The Commission has issued the enclosed Amendment No. 31 to Facility Operating License No. DPR-63 for the Nine Mile Point Nuclear Station, Unit 1. The amendment consists of changes to the Technical Specifications in response to your submittal dated November 21, 1978 as amended by letters dated January 2, and February 12, 1979.

NIAGARA MOHAWK POWER CORPORATION

NINE MILE POINT NUCLEAR STATION, UNIT NO. 1

Amendment No. 31  
License No. DPR-63

Figure-2.1.1. Flow Biased Scram and APRM Rod Block

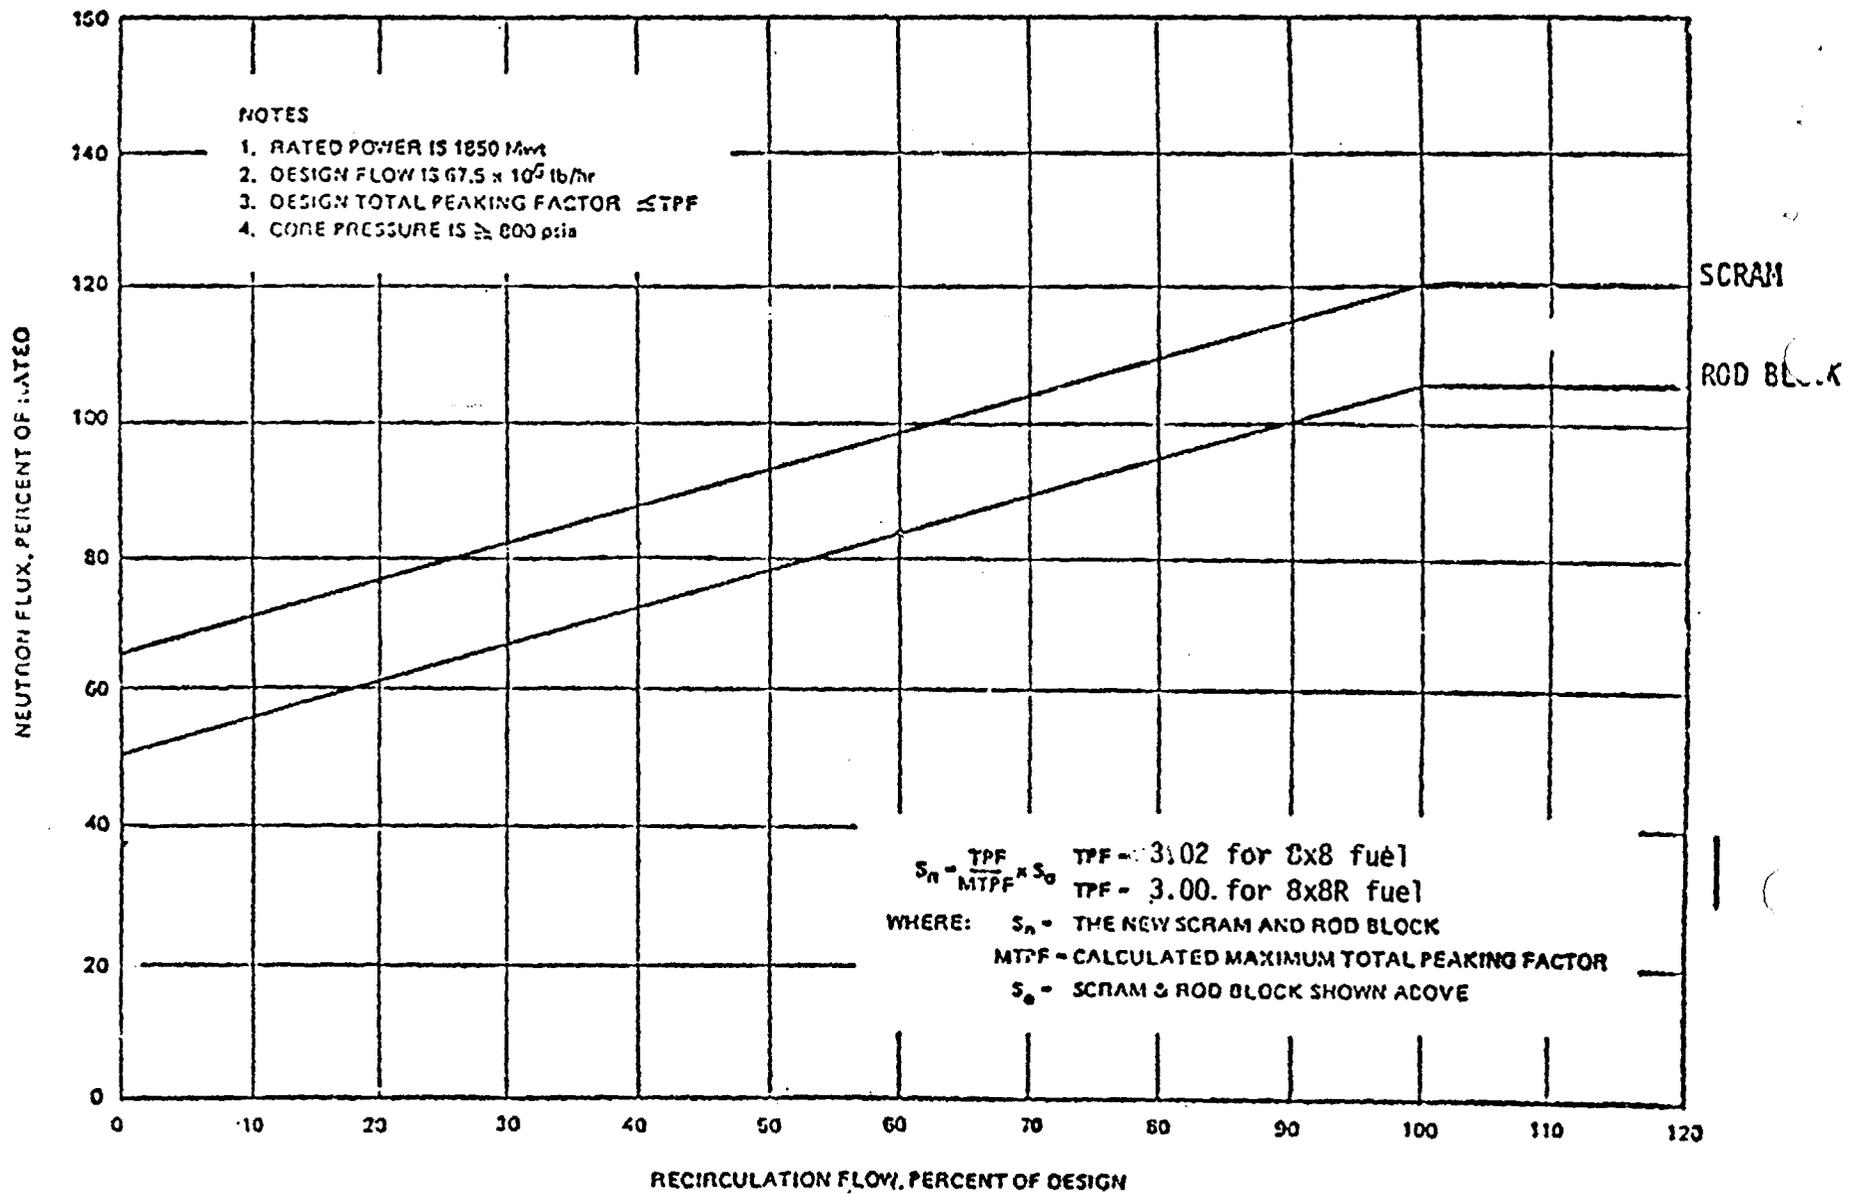
- a. The flow biased APRM scram trip settings shall be less than or equal to that shown in Figure 2.1.1.
- b. The IRM scram trip setting shall not exceed 12% of rated neutron flux.
- c. The reactor high pressure scram trip setting shall be  $\leq$  1080 psig.

The proposed 8x8R design maximum total peaking factor of 3.00 used in connection with the APRM Flux Scram and APRM Rod Block Trip Settings

has been reviewed and found to be acceptable. Additionally, we find the proposed MAPLHGR vs average planar exposure curves for the 8x8R fuel assemblies to be adequate to assure conformance with the requirements of 10 CFR 50.46 and Appendix K to 10 CFR 50.

Figure 3.1.7a MAXIMUM ALLOWABLE AVERAGE PLANAR LHGR APPLICABLE TO 8DB250 and 8DB262 FUEL AS DESCRIBED IN REFERENCE 8.

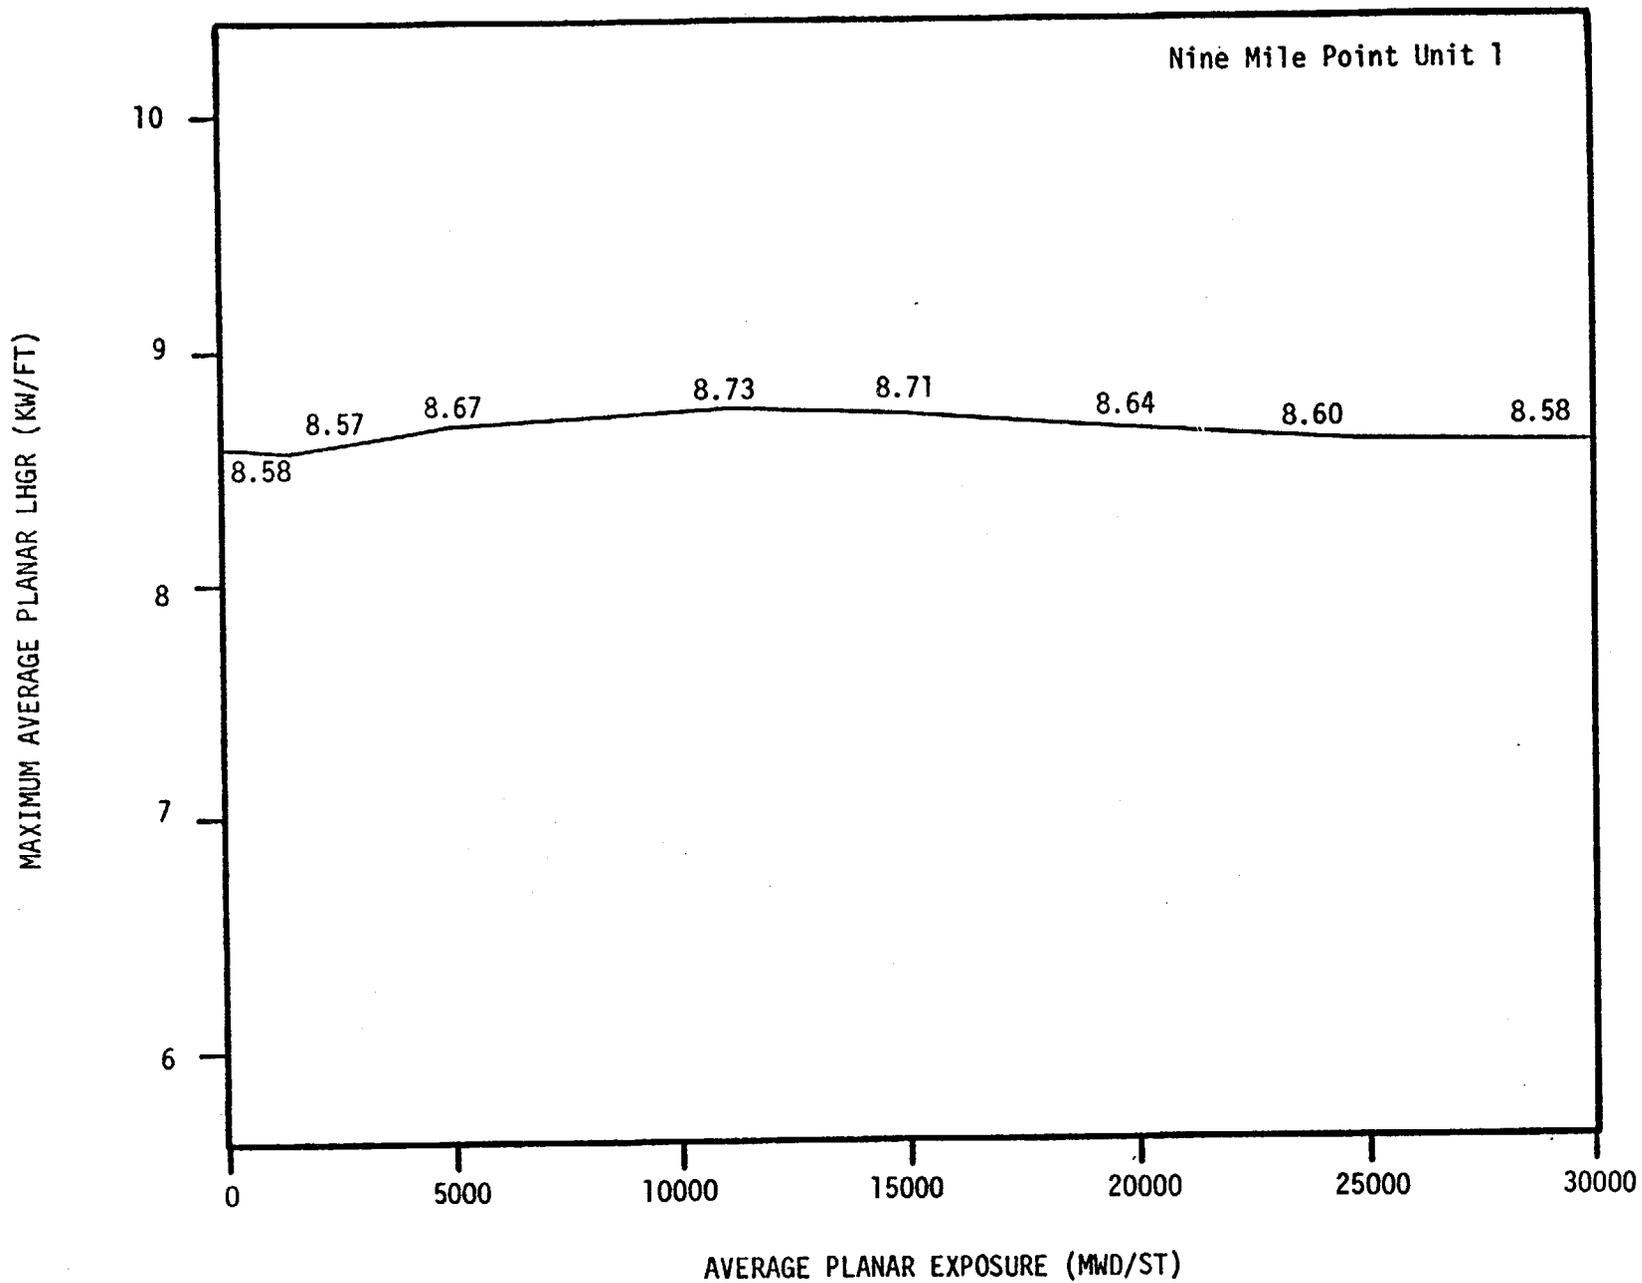
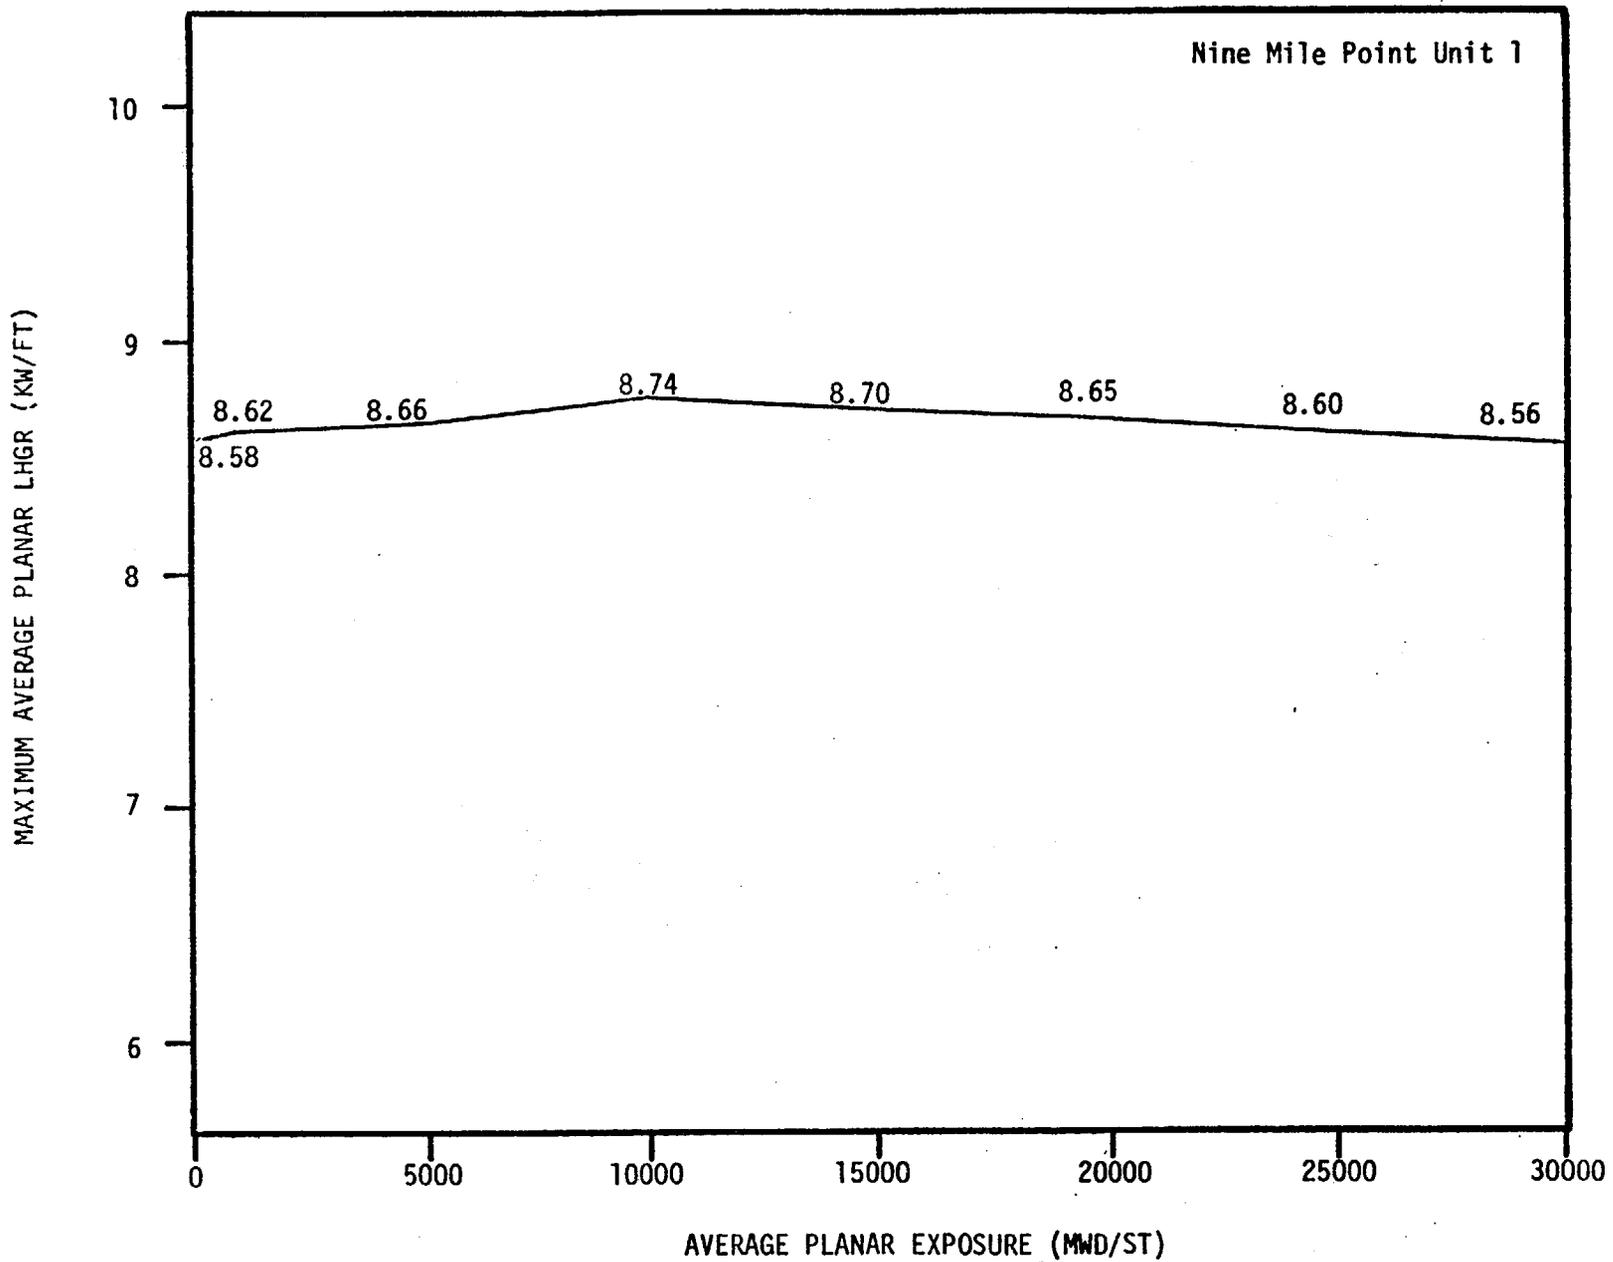
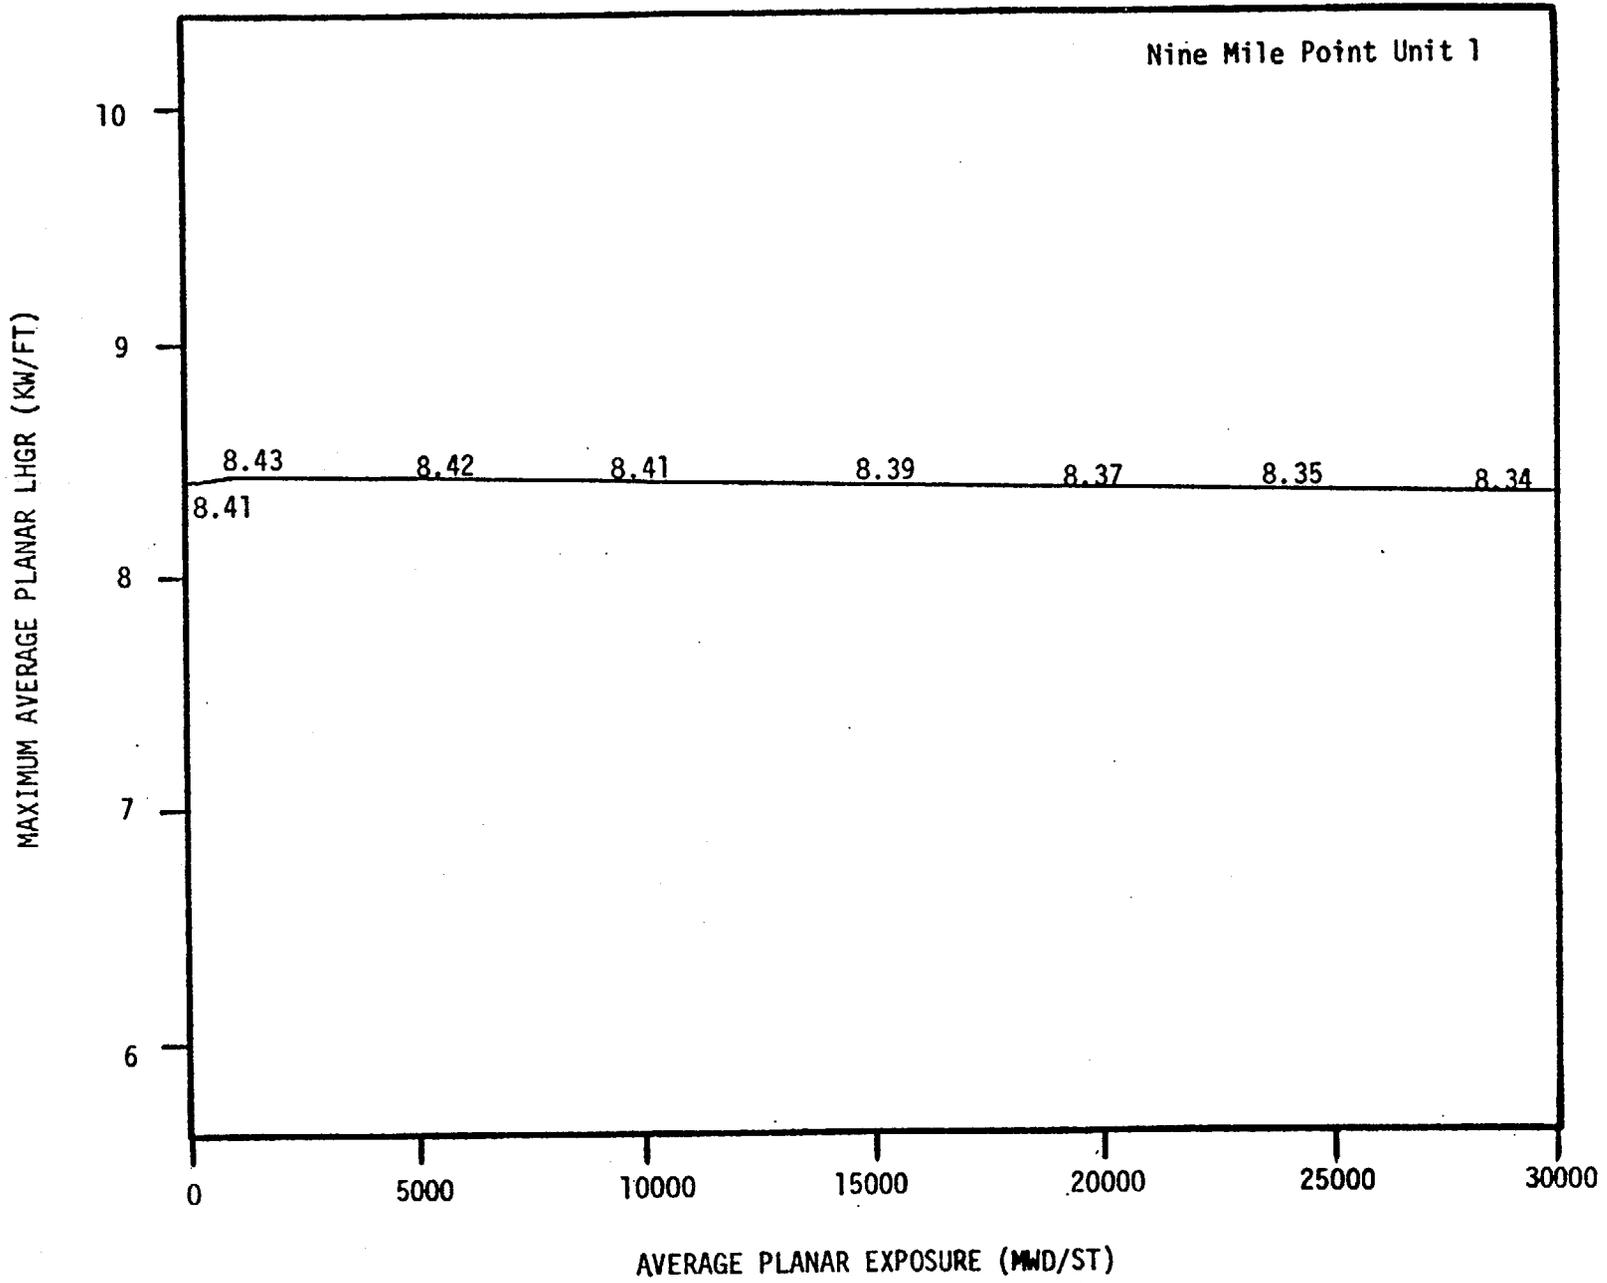
During power operation, the APLHGR for each type of fuel as a function of average planar exposure shall not exceed the limiting value shown in Figures 3.1.7a, 3.1.7b, and 3.1.7c. If at any time during power operation it is determined by normal surveillance that the limiting value for APLHGR is being exceeded at any node in the core, action shall be initiated within 15 minutes to restore operation to within the prescribed limits. If the APLHGR at all nodes in the core is not returned to within the prescribed limits within two (2) hours, reactor power reductions shall be initiated at a rate not less than 10% per hour until APLHGR at all nodes is within the prescribed limits.

During power operation with one recirculation line isolated, the APLHGR for each fuel type as a function of average planar exposure shall not exceed 98% of limiting value shown in Figures 3.1.7a, 3.1.7b, and 3.1.7c.
